DART: Optical Flame Sensor and Thermostat

Relocation

Property and Top Bus Number: DART 40FW, 304000

Issue: Optical flame sensor and roof mounted thermostat need to be moved.

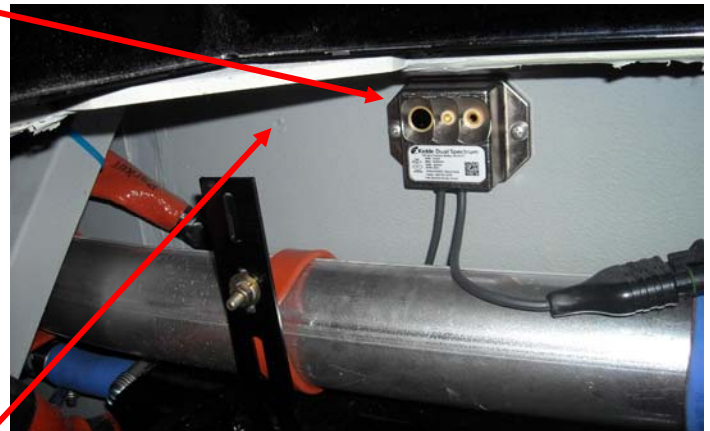
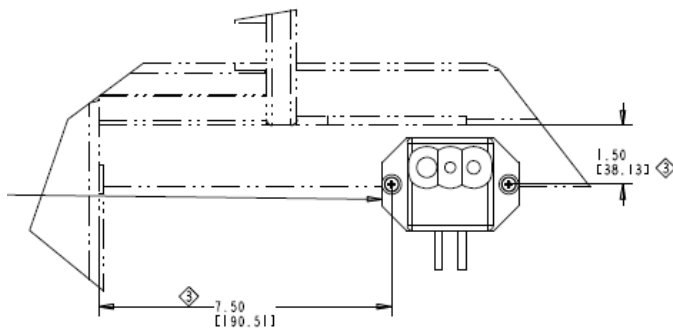
Reason/ cause: Optical sensor is blocked by a slotted bar and thermostat mounted the wrong side of the CNG cradle.

Solution: Move sensor and thermostat per this work instruction (SOI).

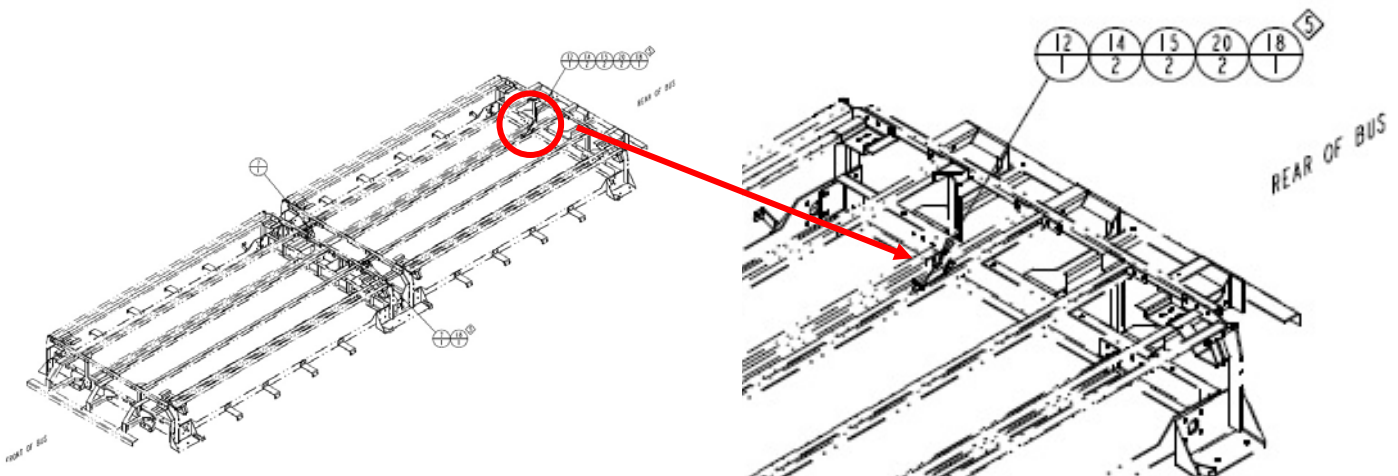
2. Open the settee seats.
3. Open the rear engine hatch.
4. Remove sensor.
5. Drill two 1/8" size holes according to the drawing below.
6. Install sensor to the new location with #10-24x1/2 PH screws, flat and lock washers.

7. Seal the original mounting holes with Fire barrier 3M sealer.
